REGATTA VITA SUBDIVISION

Revised for the January 20, 2011, meeting.

Revised for the February 17, 2011, meeting

DETAIL SITE PLAN

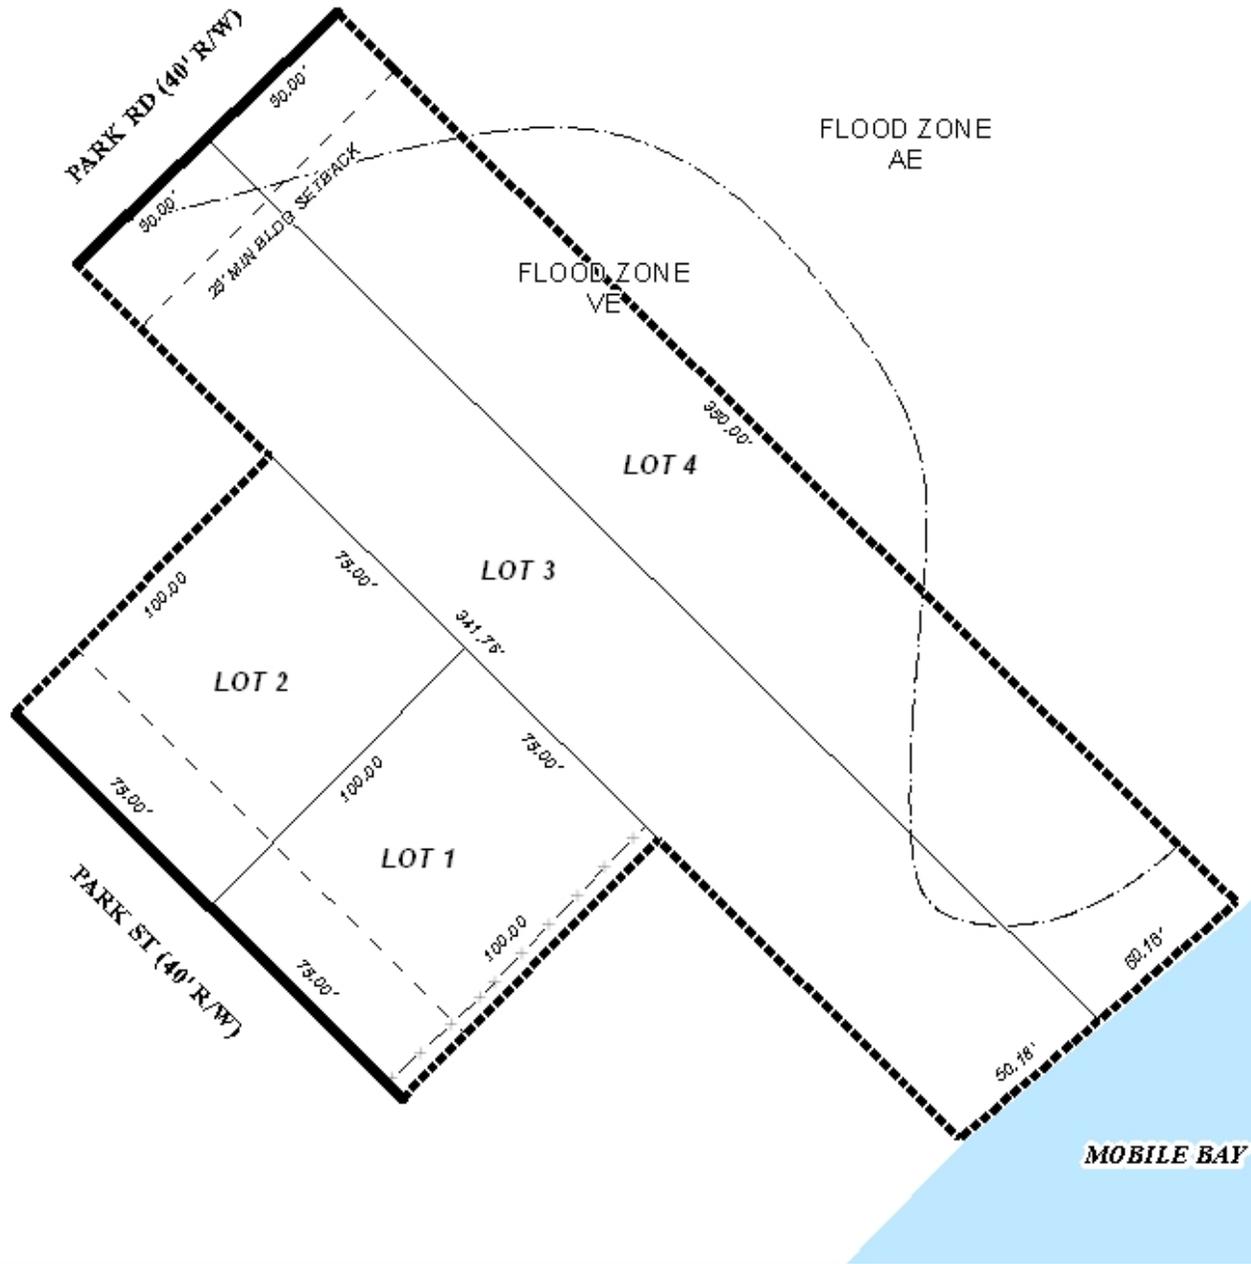
Engineering Comments: Show Minimum Finished Floor Elevation (FFE) on each lot on Plat. Need to verify location of AE/VE line scaling from FIRM maps (3-17-2010), there appears to be a minor discrepancy between line location on plat compared to FIRM map. Any proposed structure shall be constructed on pilings with the bottom of the lowest horizontal structural member to be placed above Minimum FFE. Add note to plat that there is to be absolutely no fill placed within the limits of the flood plain. Must comply with all storm water and flood control ordinances. Any work performed in the right of way will require a right of way permit.

The proposed lots 3 and 4, as depicted, do not meet the minimum frontage requirement as regulated by Section V.D.2. of the Subdivision Regulations, as the proposed lots are depicted with 50 feet of frontage; a minimum of 60 feet of frontage is required. Both of these proposed lots were originally platted with the same dimensions as proposed as Lots 26 and 27, Block 1, Alba Beach Subdivision. The re-platting is not necessary, and these lots could, in fact, be excluded from this application. However, if the applicant wishes for these lots to remain on the plat, a waiver as Section V.D.2. as it relates to the minimum frontage requirement may be appropriate. Both of the proposed lots meet the minimum lot size requirements of the Subdivision Regulations.

Regarding the proposed Lots 1 and 2, the lots, as depicted, meet the minimum size and frontage requirements as regulated by the Subdivision Regulations. However, the proposed lots have frontage on a street with a substandard right-of-way. The proposed lots front Park Street, a minor street not provided with curb and gutter. Park Street is depicted as having a 40-foot wide right-of-way. Section V.B.14. of the Subdivision Regulations requires a minor street without curb and gutter to have a minimum right-of-way width of 60 feet. As such, dedication sufficient to provide 30 feet from the centerline will be required. This dedication would reduce the

proposed lot sizes from 7,500 square feet to 6,750 square feet, below the minimum required lot size.

As stated previously, the site has frontage on Park Road to the West and Park Street to the South. Both roadways are minor streets, not provided with curb and gutter, and both are depicted with an existing right-of-way of 40 feet. The Subdivision Regulations require minor streets without curb and gutter to have a minimum right-of-way of 60 feet; as such, dedication sufficient to provide 30 feet from the centerline should be required.

Additionally, the entire subdivision is located within a FEMA designated coastal hazard flood zone. This may indicate that dense residential development may not be appropriate in this area.

Given that proposed Lots 1 and 2 will fall below the required minimum lot size requirement and the site's situation regarding coastal flood hazard, the two new lots may be inappropriate.

- 1) with required dedications, Lots 1 and 2 will not meet the minimum size requirements; and
- 2) the substandard lots are located within a FEMA designated flood zone with coastal hazard, and thus the property may be proposed for overdevelopment.

- 1) with required dedications, Lots 1 and 2 will not meet the minimum size requirements; and*

- 2) *the substandard lots are located within a FEMA designated flood zone with coastal hazard, and thus the property may be proposed for overdevelopment.*
